Los Alamos Community Plan Update Proposed Final EIR and Revision Letter
(08EIR-05, RV01)

Subject: **Revisions (RV01) to the Proposed Final Program Environmental Impact Report (08EIR-05) -- Finding that State CEQA Guidelines Section 15088.5 (b) applies to the Los Alamos Community Plan Update: Planning and Development Case Numbers 08GPA-04, 08ORD-11, and 08RZN-02**

LOS ALAMOS COMMUNITY PLAN
FINAL ENVIRONMENTAL IMPACT REPORT
08EIR-05

REVISION LETTER (**RV01**)

Area to be Removed from Affordable Housing Overlay

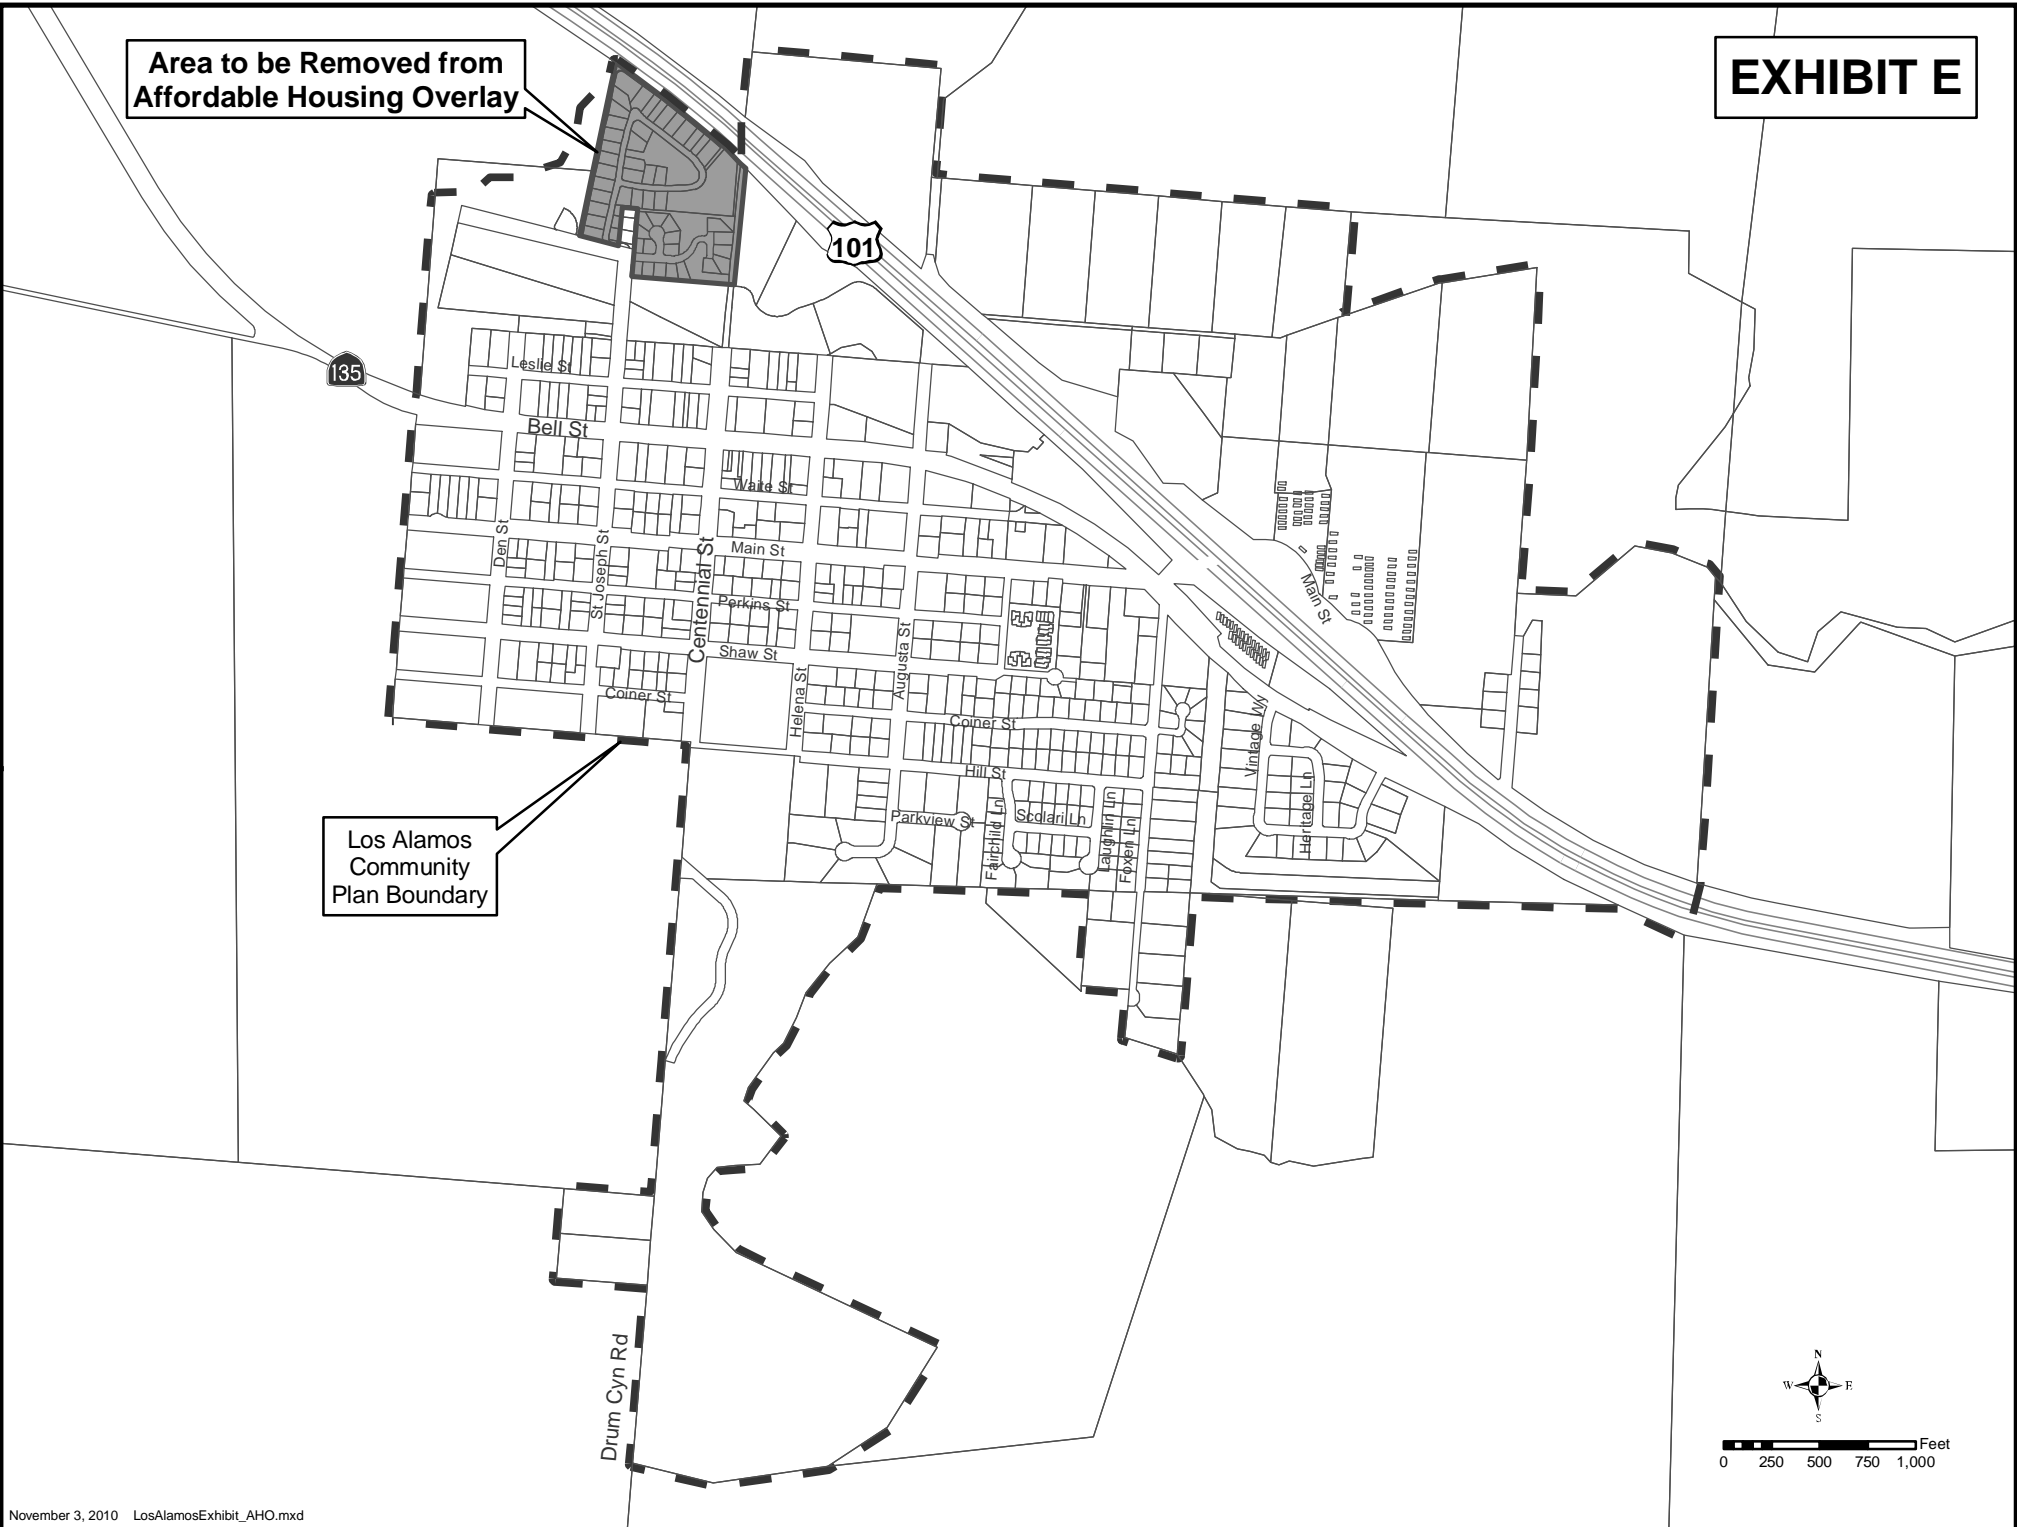
The 1994 LACP and the July 2010 version of the Draft LACP update contain two maps depicting the Affordable Housing (AH) Overlay applicable to properties in the northwest portion of the Plan Area (Figure 6: Zoning Overlays, Page 37, and Figure 7: Affordable Housing Overlay, Page 39). The Planning Commission recommended removing the AH Overlay designation from properties that developed as a residential single family subdivision without utilizing the density bonus available under the AH overlay. Attachment A to this EIR Revision Letter lists the parcels being removed from the AH Overlay along with a map showing the area of removal.

The AH Overlay does not alter the assumptions used in preparing the baseline used in the proposed FIER (Table 2-2, FEIR Page 2-11) to analyze the potential environmental impacts associated with the land use changes in the proposed LACP update. Rather, these changes serve to clarify existing information and eliminate redundancy. Therefore, no change to the FEIR analysis is warranted by these minor map revisions.

Los Alamos Bell Street Corridor On-Street Parking Study

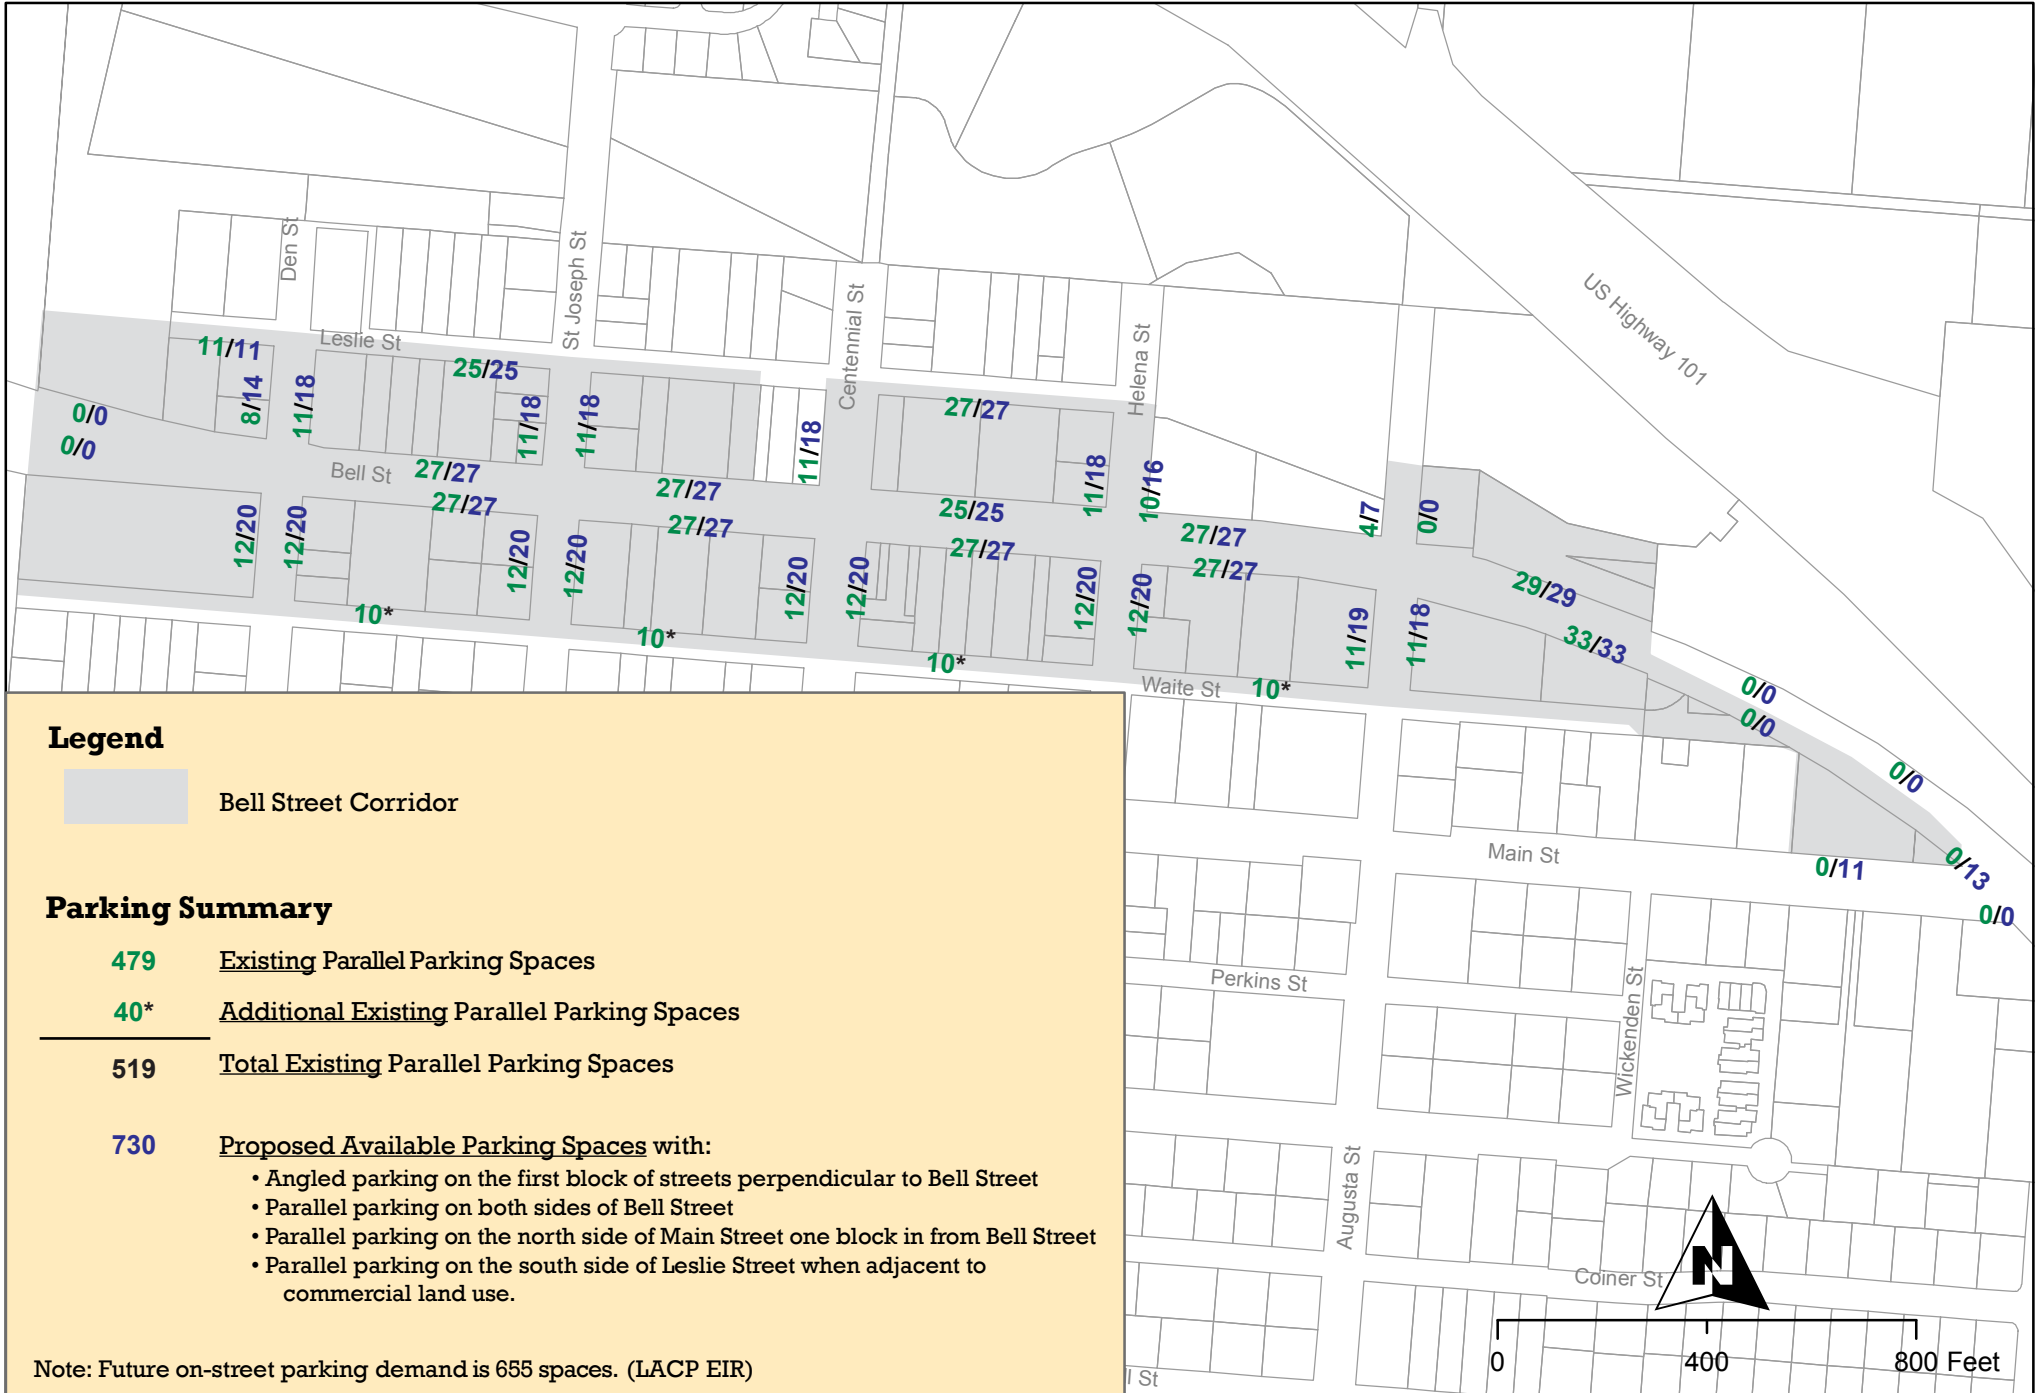
Staff reviewed the parking analysis in the FEIR and prepared an updated parking analysis which includes amended on-street parking supply information (Attachment B to this FEIR Revision Letter). The FEIR parking study identified 479 existing on-street parking spaces in the CM-LA zone district. Striping of angled parking along cross streets one block north and south of Bell Street would add an additional 211 parking spaces. Existing on-street parking along the north side of Waite Street was not included in the parking study, but conservatively would add an additional 40 spaces, bringing the total supply with future angled parking to 730 spaces.

The additional 188,550 square feet of commercial uses would require 378 on-street parking spaces for a total on-street parking demand of $(277 + 378) = 655$ spaces. Therefore, the future supply of on-street parking in the CM-LA zone district (730 spaces) is adequate to accommodate parking demand. The EIR also assumed that all new commercial uses in the CM-LA would meet their parking requirements through on-street parking.¹
